Curbline

Outstanding Issues

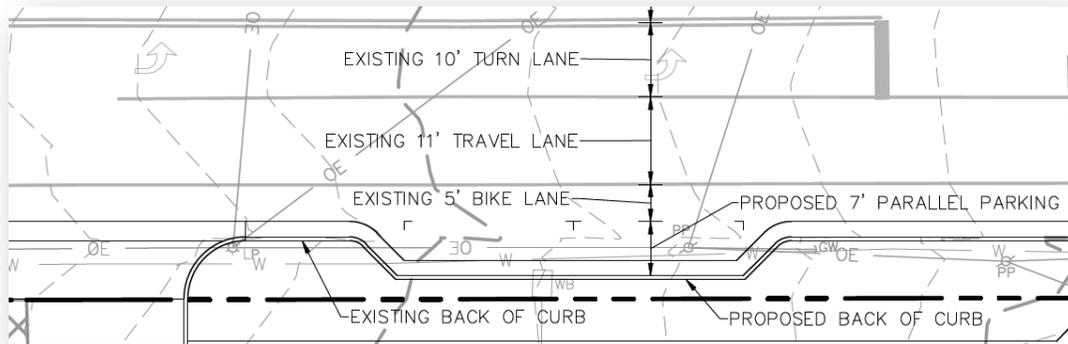
The proposed zoning district has a setback measured from an existing or proposed future curbline. The location of the future curbline is TBD (to be determined prior to public hearing).

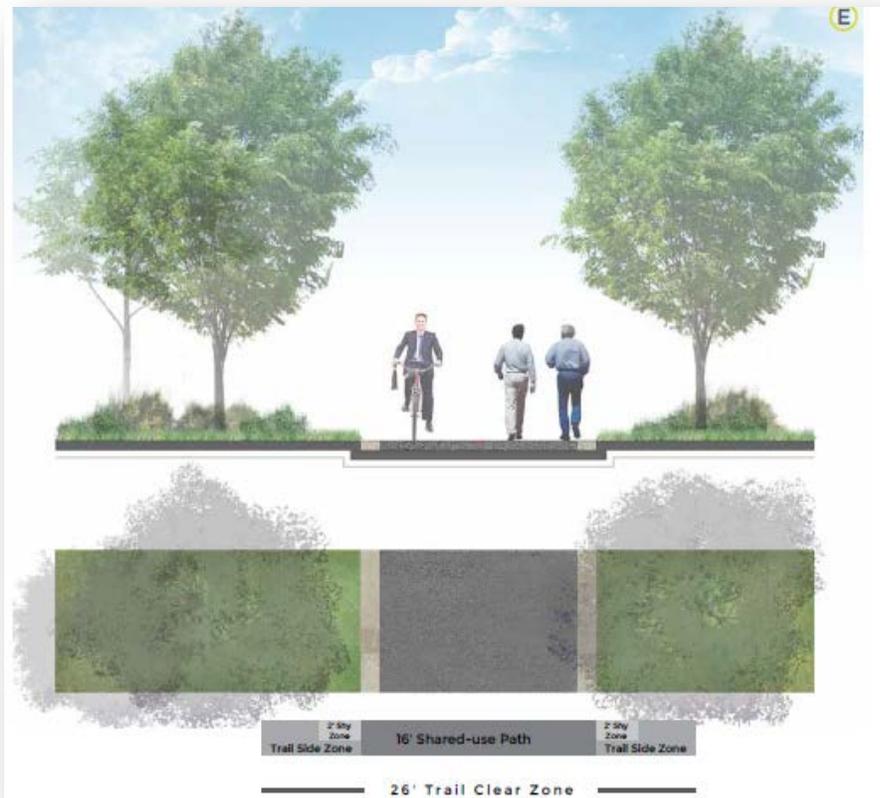
2. CDOT requests that the petitioner construct the new back of curb on Siegle Ave. in a location that allows for a new 6' bike lane in addition to the on-street parking that is currently being proposed on the site plan. Please revise the site plan to clearly show this new back of curb location accurately.
3. CDOT recommends that the petitioner construct the Cross Charlotte Trail and dedicate a 26' permanent easement for maintenance. The cross section for this segment of the trail should be a 16' paved shared use path with an additional 5' of clear zone space on both sides (total of 26' wide). Please see the proposed cross section below:

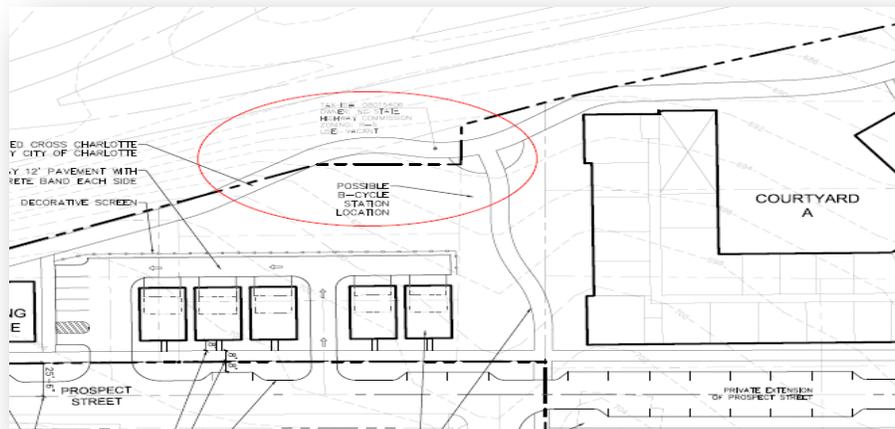
6. CDOT is currently seeking a Tiger Grant for a bicycle/pedestrian bridge that would cross US-74 parallel to the existing Central Avenue Bridge. The exact tie in location is yet to be determined but it is anticipated to be in the general area as shown below:

For this reason CDOT recommends that a note be added to the site plan stating that “in the case that the City’s Tiger Grant is awarded for the Cross Charlotte Trail Bridge, the developer agrees to provide the needed construction easements and any permanent easements in this area to allow for the construction of this bridge”.
